## Development Review Division

### MEMORANDUM

**SUBJECT:** SP20-118; Parker and Pine F1 L4 - Car Wash  
Review Comments 02

LANDSCAPE PLAN  
SHEET TITLE  
SHEET NUMBER

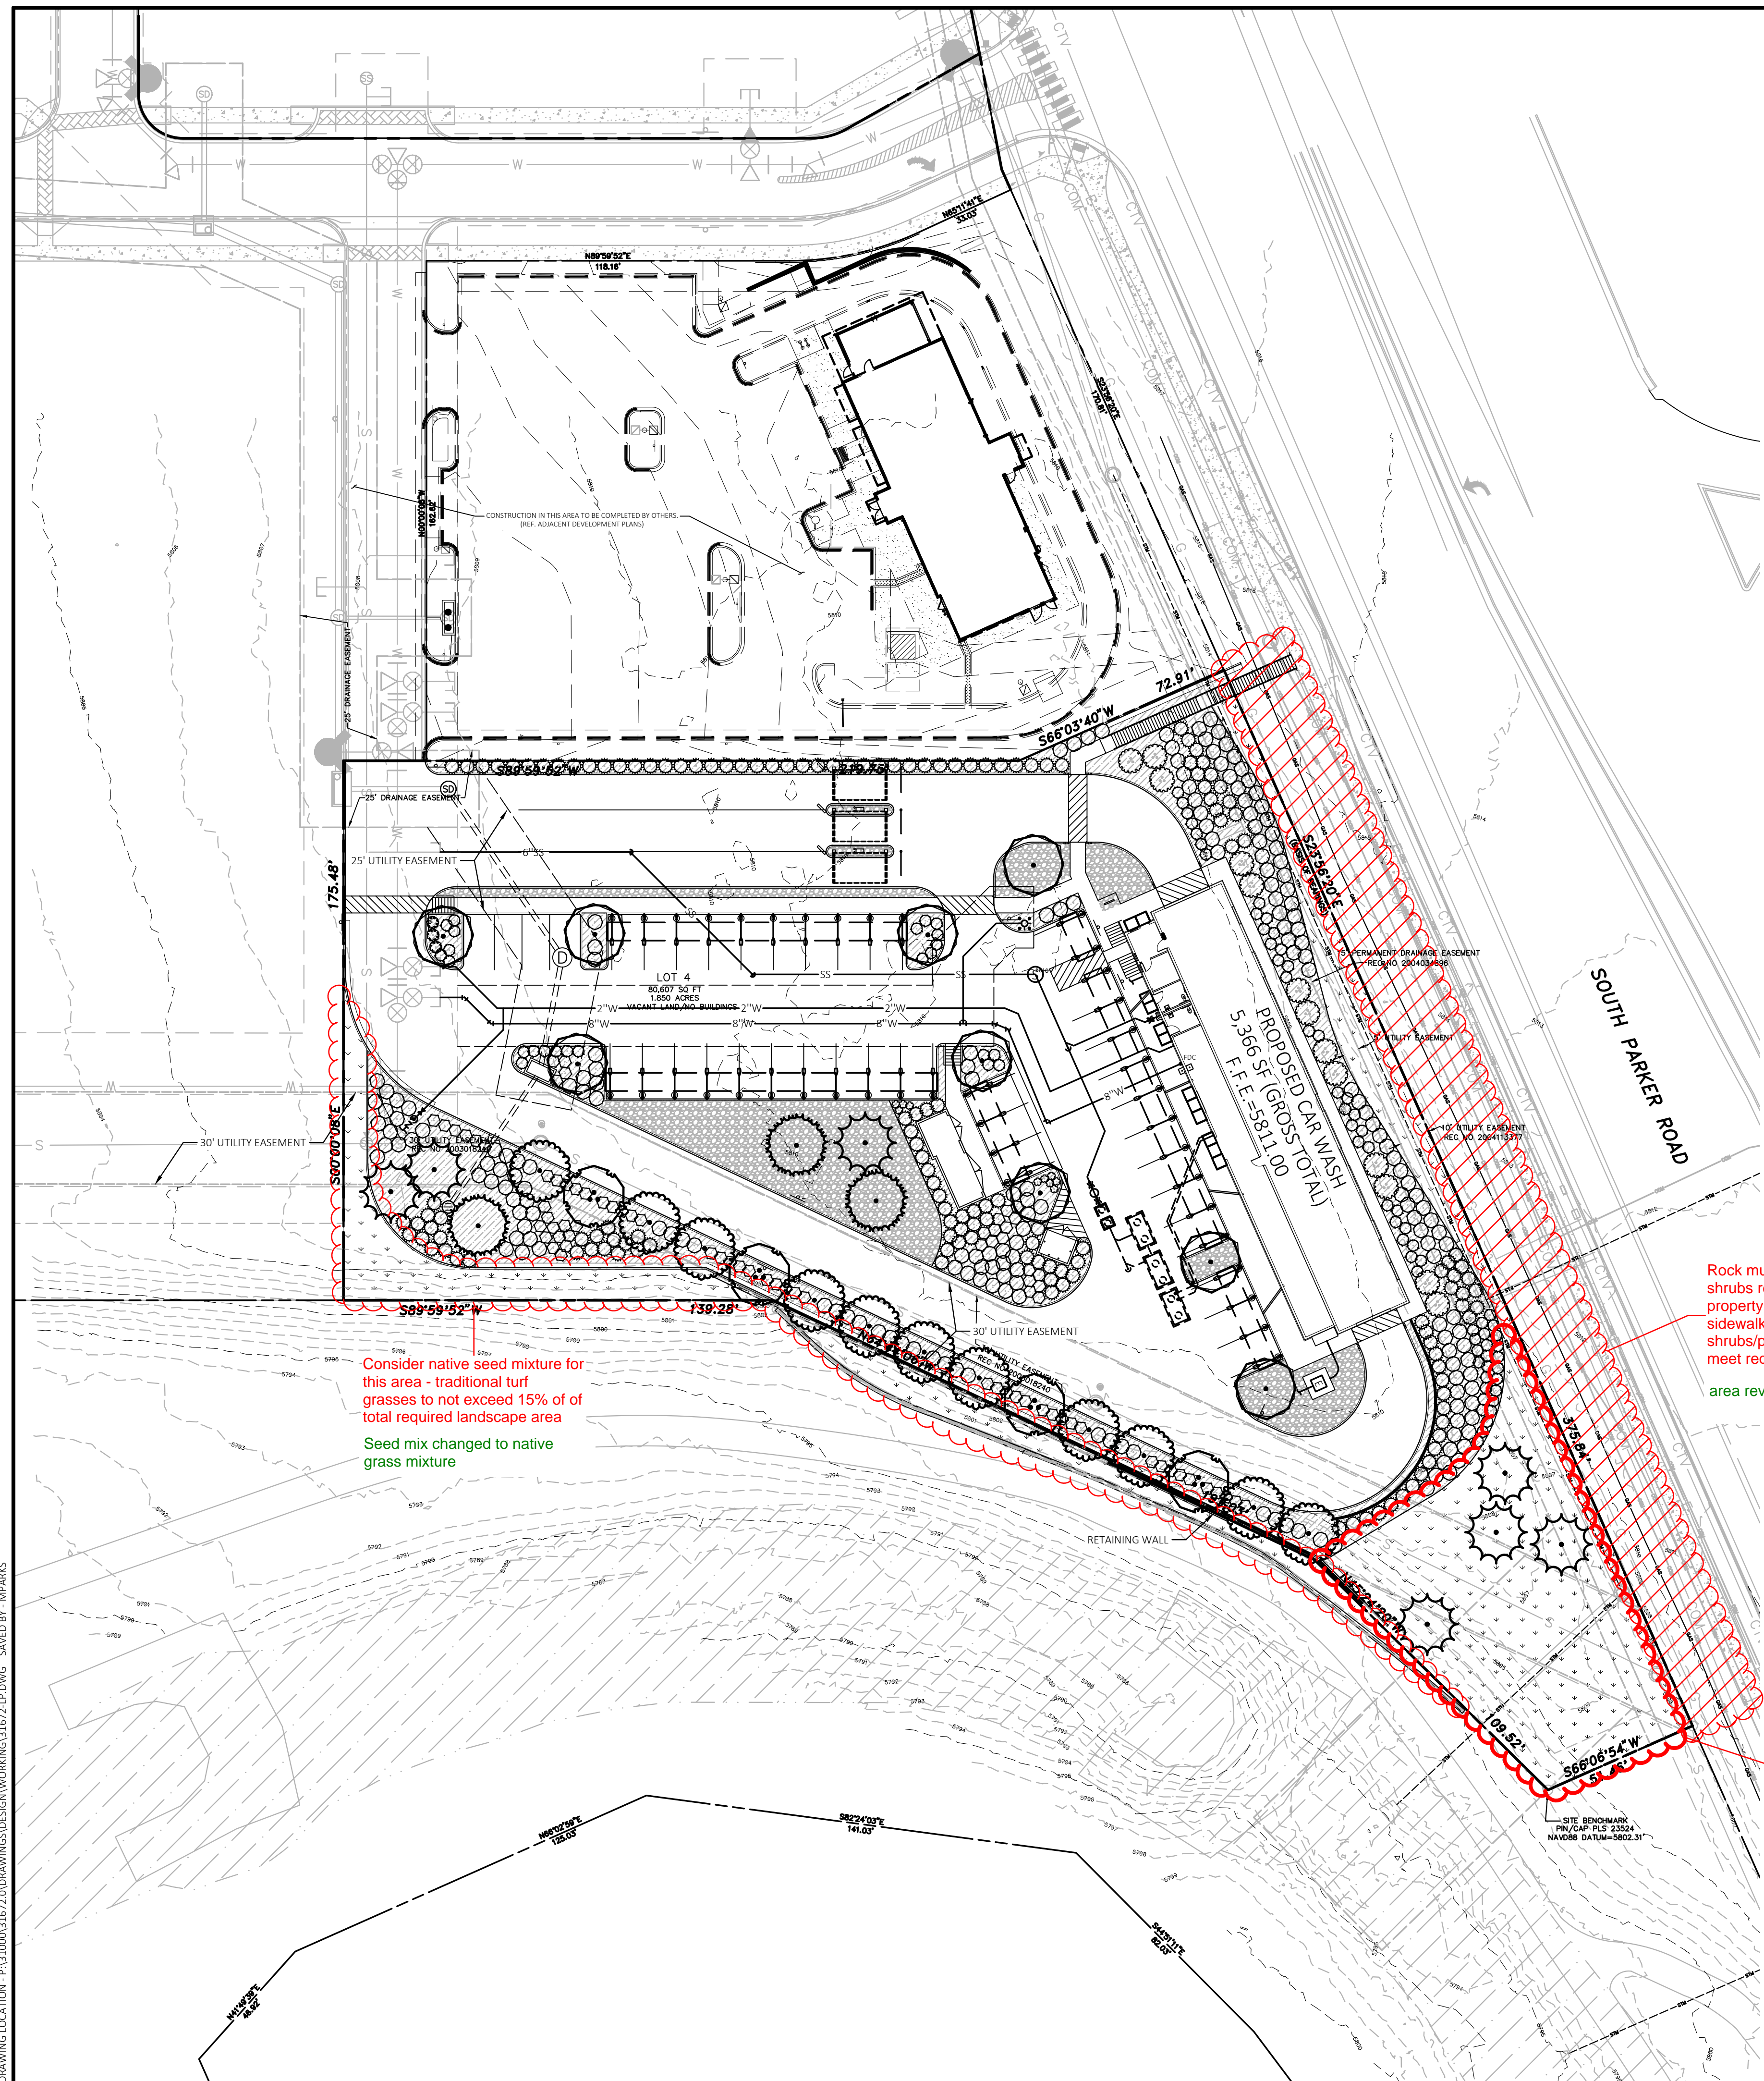
city comments for landscape  
(see page3) - mmc
